# Access Compliance Report

## Public Rights-of-Way

Intersection ID: 26458	Main Street: BRECHIN_DR	Cross Street: BROADFORD_CT	Location:	N
ADA ID: F0BA80077818	Ramp Type: Perp	Initial Pass/Fail: Fail	Overall Compliance: No	Severity Score: 35
Codes/Mitigation Info/Possible Solution		Field Measurements/Component Compliance

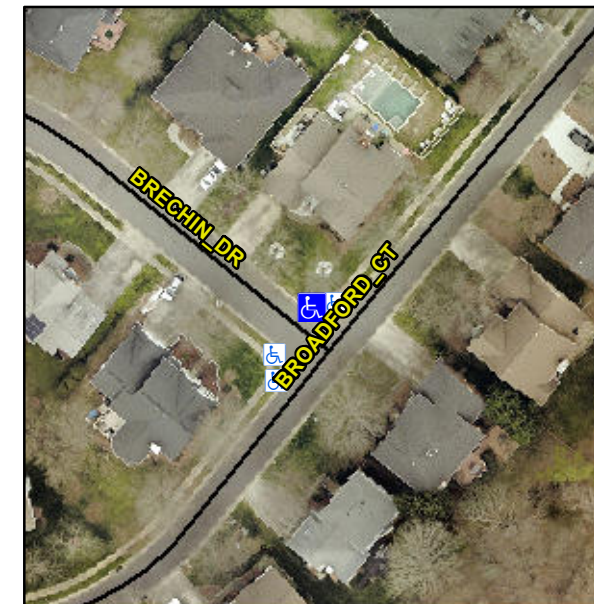
**Not Found, R304.5.1**

Compliance	Description	Data	Compliance	Description	Data
N/A	Ramp Length (in)	90.0	Yes	Ramp Slope (%)	7.5
No	Ramp Width (in)	25.0	Yes	Ramp XSlope (%)	0.2
N/A	Flare Type LT	N/A	N/A	Flare Type RT	N/A
N/A	Flare Slope LT (%)	N/A	N/A	Flare Slope RT (%)	N/A
N/A	Flare Traversable LT?	N/A	N/A	Flare Traversable RT?	N/A
N/A	Landing Length (in)	N/A	N/A	DWS Provided?	N/A
N/A	Landing Width (in)	N/A	N/A	DWS Contrast?	N/A
N/A	Landing Slope (%)	N/A	N/A	DWS Length (in)	N/A
N/A	Landing X Slope (%)	N/A	N/A	DWS Full Width?	N/A
N/A	Landing Curb? (Y/N)	N/A	N/A	DWS Offset (in)	N/A
N/A	Shared Landing?	N/A			
N/A	Gutter Ponding?	N/A	N/A	Gutter Slope (%)	N/A
N/A	Gutter Lip Ht (in)	N/A	N/A	Gutter X Slope (%)	N/A
N/A	Painted X Walk1?	No	N/A	Painted X Walk2?	N/A
	X Walk 1 Direction	To SW		X Walk 2 Direction	N/A
N/A	X Walk 1 Width (in)	N/A	N/A	X Walk 2 Width (in)	N/A
	X Walk 1 Slope (%)	0.2		X Walk 2 Slope (%)	N/A
	X Walk 1 X Slope (%)	2.0		X Walk 2 X Slope (%)	N/A

**Remove & Replace Entire Ramp.**
